SYNCPOS CARD OUT OF PRODUCTION (Danfoss)

GEA Procomac informs that the Syncpos card installed on the Danfoss VLT5000 inverter present in the Synchro Blower-Filler **has been out of production since 2008.**

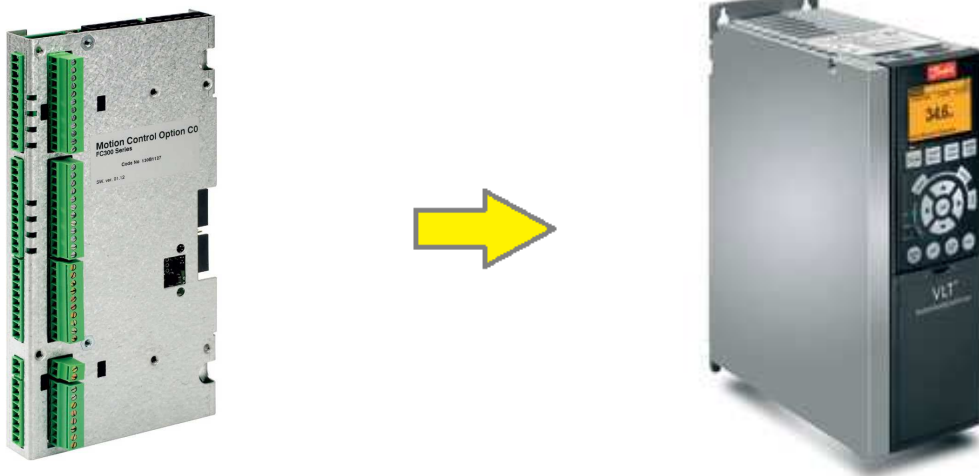
In case of abnormalities or damages of the Danfoss equipment (Syncpos card or Inverter VLT5000) which handle the interfacing of the Filler with the Blower, the following possibilities can be prefigured:

- a) **Abnormality Syncpos card:** it will be possible to continue supplying the spare part up until the end of 2013.
- b) **Abnormality Inverter:** the spare parts of the inverter series VLT5000 are no longer available. It will be possible however to proceed with the repair of the inverter at a Danfoss Repair Center up until the end of 2013. **For the repair the supplier requires a schedule of approx 45/60 days.**

Attention: the Syncpos card is not compatible with the series of Danfoss Inverter FC300 (the new series of Inverter which has replaced the VL T5000 series)

GEA Procomac communicates the possibility to effect an up-grade which foresees the replacement of the current configuration (Inverter VLT5000+ Syncpos Card) with equipment of the latest generation.

- Replacement of the VLT5000 Inverter with the equivalent Inverter FC300
- Replacement Syncpos card with MCO305 card
- Software conversion Syncpos card
- PLC software modifications for the interfacing with the new MCO305 card
